# 1963 - 1982 Corvette: Chevrolet Service News: Rear Spring Removal Service Update

**Subject:** Rear Spring Removal  
**Model and Year:** 1968 Corvette  
**Source:** Chevrolet Service News  
**Page Number:** NA  
**Date:** August 1968

Revise the procedure appearing on page 4-20 of the 1968 Passenger Car Chassis Service Manual covering Corvette Rear Spring Removal as follows:

Fig. 6—Removing Corvette Rear Spring

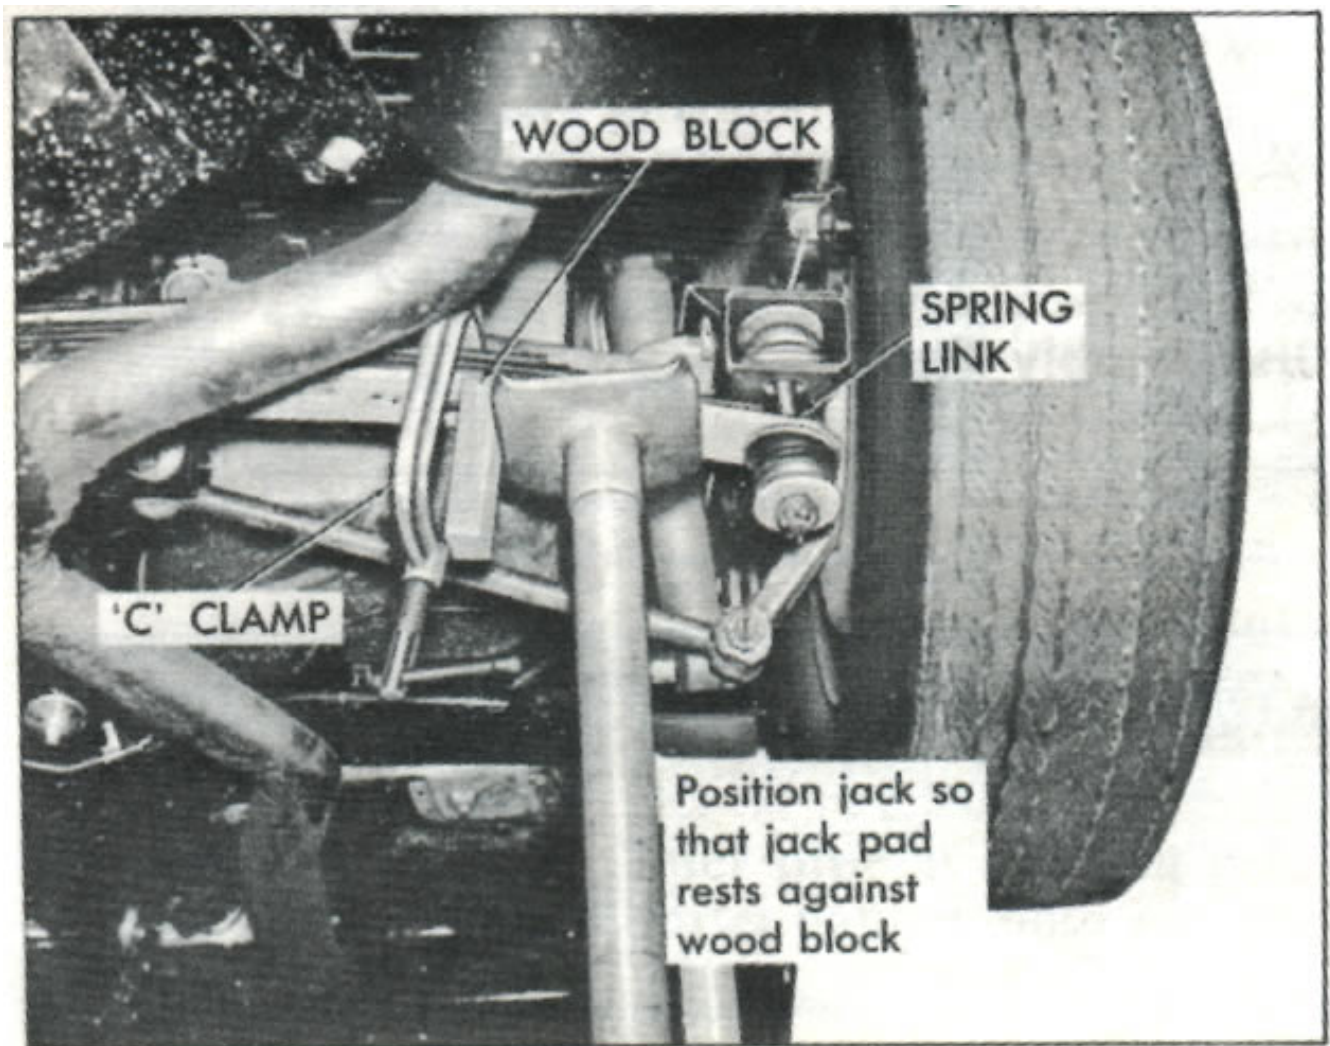
## **Removal (Reference Fig. 6)**

1. Raise rear of vehicle at frame.
2. Install "C" clamp on spring approximately 9" from one end. Tighten securely.
3. Place floor jack under spring with lifting pad of jack inboard of link bolt near the "C" clamp. Place a suitable piece of wood between jack pad and "C" clamp screw. *NOTE - The "C" clamp is merely acting as a 'stop' so that the jack won't slip when the spring is released. The wood block is used to protect the "C" clamp threads from being distorted due to contact with the jack pad.*
4. Raise jack until all load is off link. Remove link cotter key and link nut. Remove cushion.

5. Carefully lower jack until spring tension is released.
6. Repeat steps 2-5 for other side.
7. Remove four bolts and washers securing spring center clamp plate (reference Fig. 51 in Manual).
8. Drop spring and slide out from under vehicle (reference Fig. 51 in Manual).
9. To install, reverse Removal steps 1-8.
